CONTRACT CHANGE ORDER NO. 31452
SHEET 2 OF 7

MARK	DATE	DESCRIPTIONS	BY	CH'D	CCO#
1	08/01/13	REMOVE AND TEST SAMPLE RODS	CC	MN	31452
0	06/11/13	REMOVE, REPLACE, AND TEST SAMPLE RODS	CC	MN	31451

SAN FRANCISCO OAKLAND BAY BRIDGE
EAST SPAN SEISMIC SAFETY PROJECT
SELF-ANCHORED SUSPENSION BRIDGE
(SUPERSTRUCTURE & TOWER)

TEST RIG DETAILS NO. 10

LAYOUT PLAN-TEST RIGS #8, 9, 10, 11

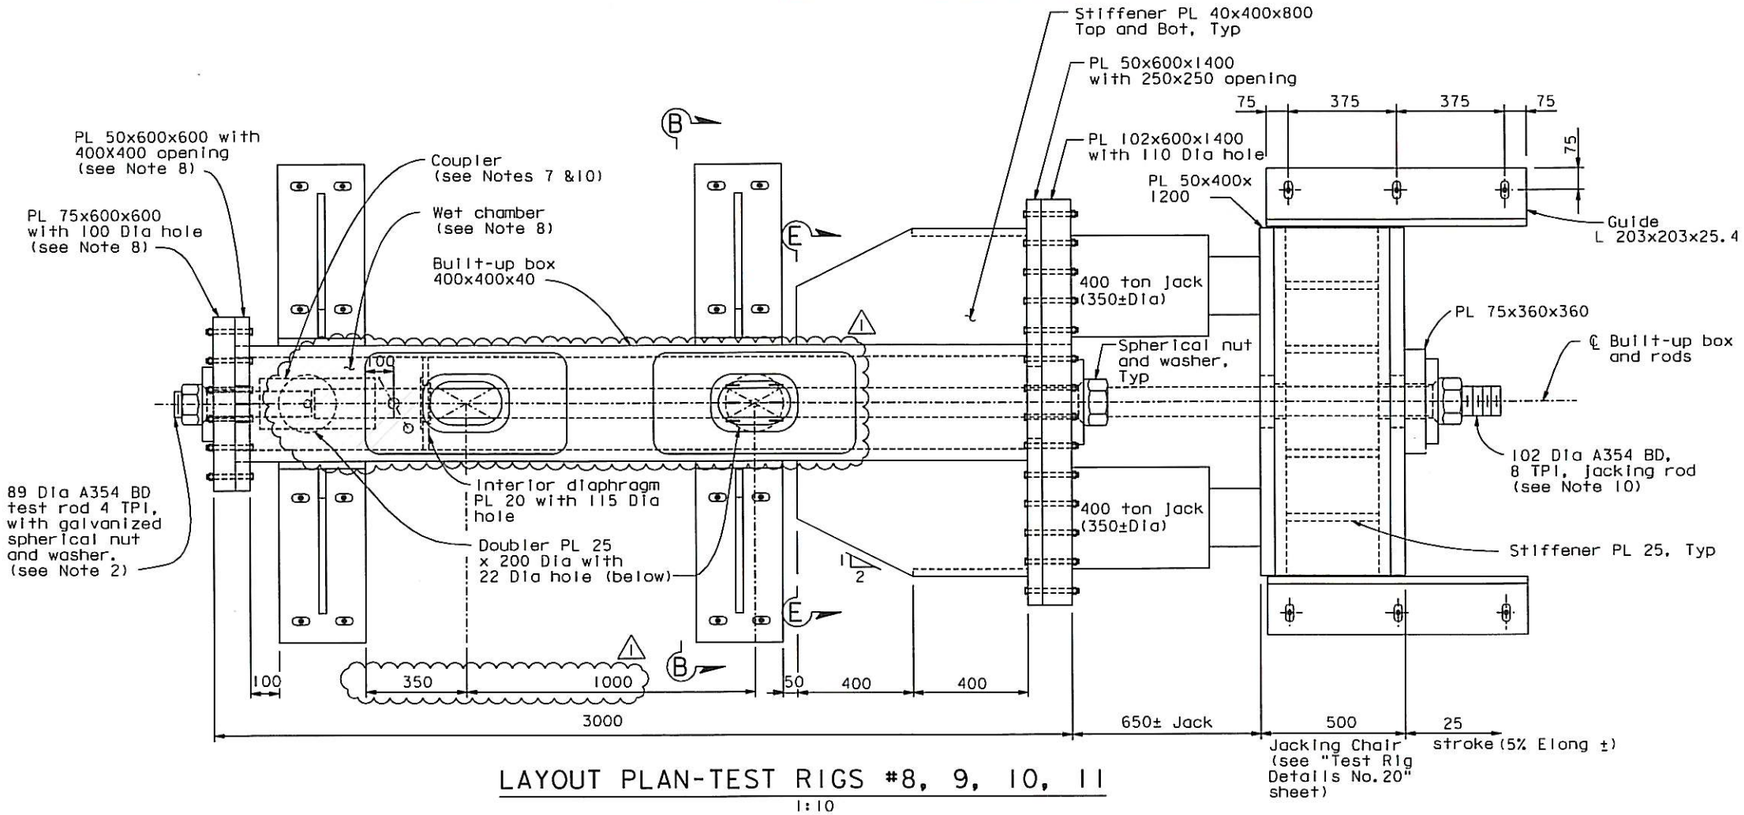
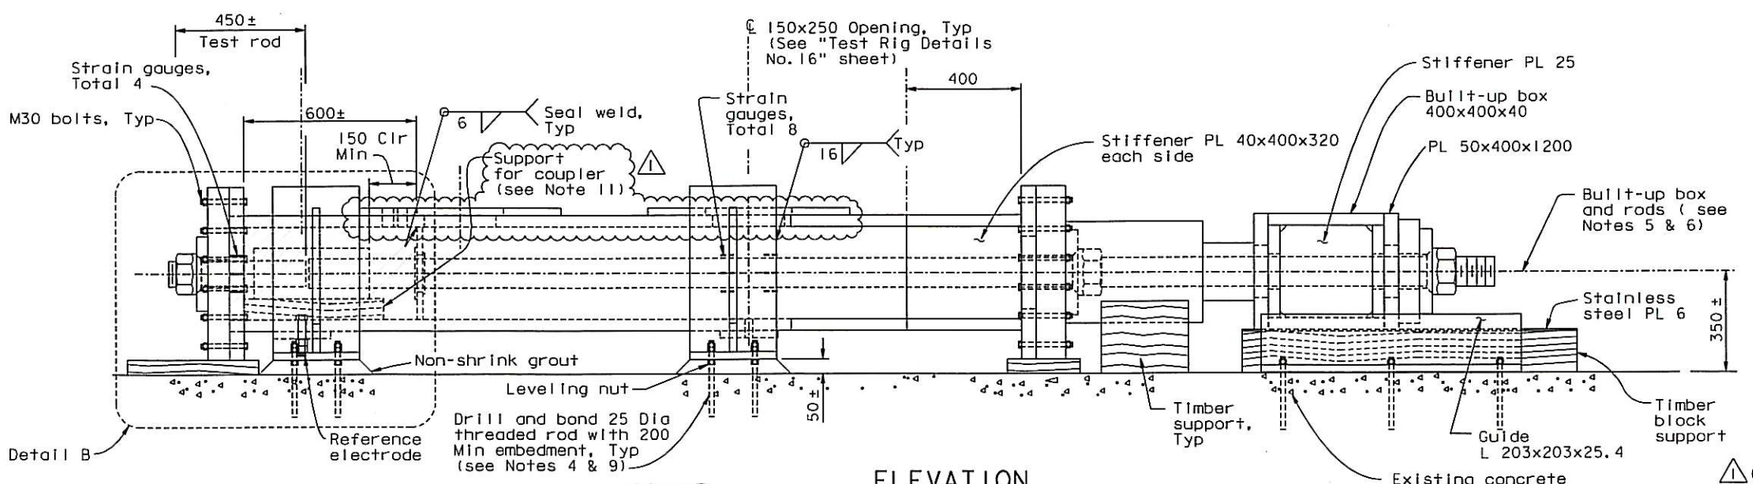
1. For Section B-B, see "Test Rig Details No. 15" sheet. For Detail B, see "Test Rig Details No. 17" sheet. For "Section E-E, see "Test Rig Details No. 18" sheet.

2. Minimum of 75 mm of threads of the rod shall be submerged in the NaCl solution at the start of the test.
3. Built-up box 400x400x40 shall be used.
4. The drill and bond 25 Dia threaded rods shall have minimum allowable strength of 45 kN in tension and 30 kN in shear per threaded rod. Provide double nuts, snug-tight against steel plates.

5. Test assembly shall be placed level.
6. CL of built-up box and rods shall be aligned to within 4 mm.
7. For coupler detail, see "Test Rig Details No. 16" sheet.

8. All interior wetted surfaces of wet chambers, including inside of holes, shall be painted with two coats of epoxy based system or equivalent. Surface preparation and application procedure shall be per manufacturers' recommendations.

9. Existing concrete shall be 300 thick and shall have minimum strength of 14 MPa, confirm by testing of corings. In the event that foundation thickness or strength cannot be confirmed, reinforced concrete slab foundation shall be provided as shown on "Test Rig Details No. 21" sheet.

10. Coupler and portion of jacking rod submerged in NaCl solution shall be painted with two coats of epoxy based system or equivalent. Surface preparation and application procedure shall be per manufacturers' recommendations.

11. Contractor to propose material for Engineer's review and approval. Material shall be non-metallic and non-expanding in contact with water.

TEST RIG DETAILS NO. 16

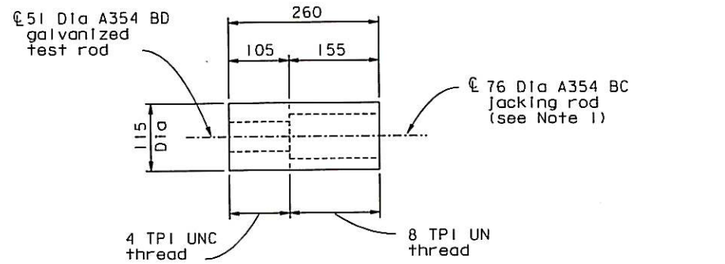
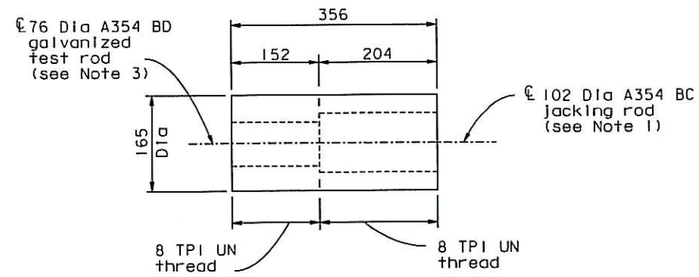
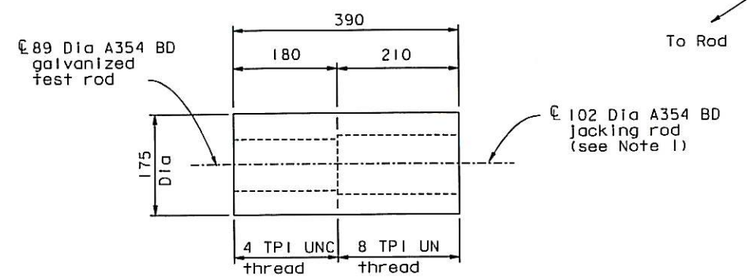
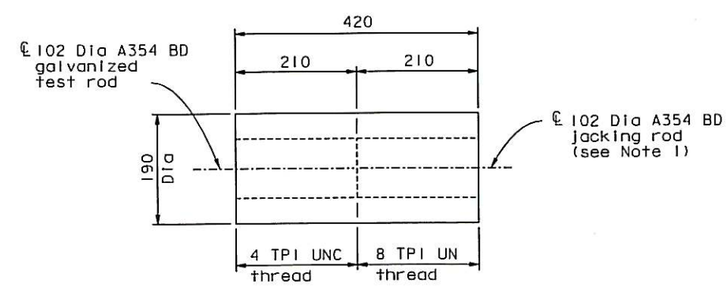
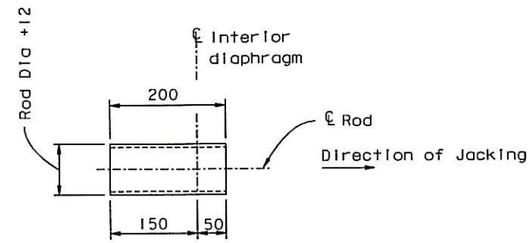
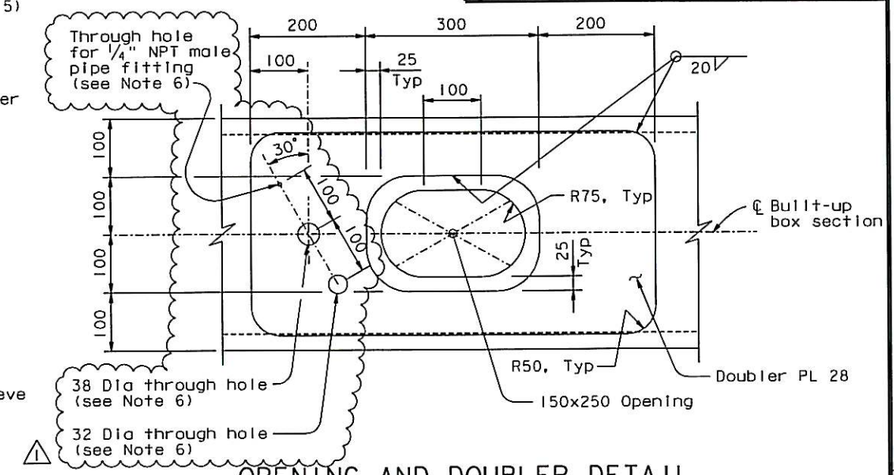
1. Coupler and jacking rod shall be fabricated from AISI 4340 materials, with mechanical properties conforming to ASTM A354 BC. Tapping of the coupler threads shall account for the thickness of galvanizing on the test rods.
2. Groove shall be used to confirm an outflow of NaCl solution through the threads. Upon confirmation, seal groove with closed cell backer rod, plumber putty or similar material.
3. New threads at this end of test rod shall not be galvanized.
4. Cylindrical sleeve shall be fabricated from AISI 1010 material. Inside of sleeve shall be tapped to be compatible with the threaded rod.
5. Apply plumber dope or equivalent to seal threads against leaks. Submit product for review and approval by the Engineer.
6. Holes required at wet chambers only. For locations, see "Test Rig Details No. 11 thru No. 14" sheets. (1)
